生産終了商品のお知らせ

多軸モーションコントローラ

- ・ACC-5Eシリーズ(3-3437A-00-□000-□100)の生産終了のお知らせとなります。
推奨代替商品はACC-5E3シリーズ(3-4017A-00-A001-□100)となります。
- ・プログラムの互換性がないため、プログラミングツールを用いた操作方法が変更となります。

■端子配置／配線接続

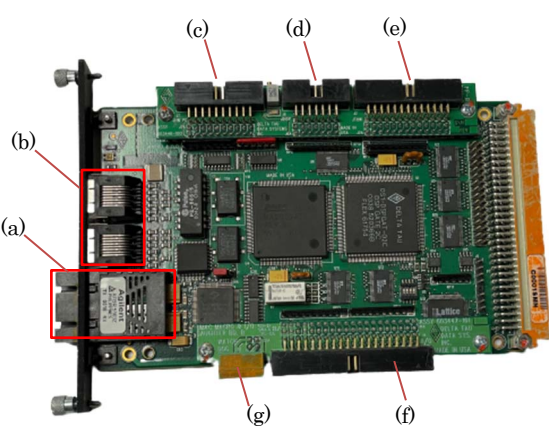
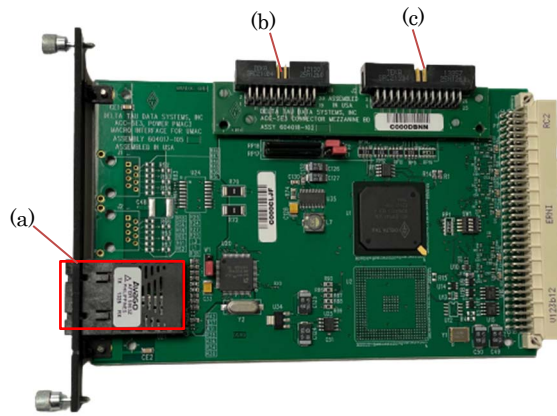
<p>生産終了商品 3-3437A-00-□000-□100</p>	<p>推奨代替商品 3-4017A-00-A001-□100</p>
 <p>(a) 2- MACRO SC-Style ファイバーコネクタ (b) MACRO RJ-45 コネクタ (c) J7 - JHW (ハンドホイールポート、パルス、方向出力の組み合わせ :20ピンボックスヘッダー) (d) J6 - ディスプレイ (e) J2-JTHW (サムホイールポートコネクタ:26ピンボックスヘッダーコネクタ) (f) J4- I/O (g) TB1- Watchdog</p>	 <p>(a) 2- MACRO SC-Style ファイバーコネクタ (b) J1 Top: ハンドホイールポート (c) J2 Top: 汎用I/Oポート</p>
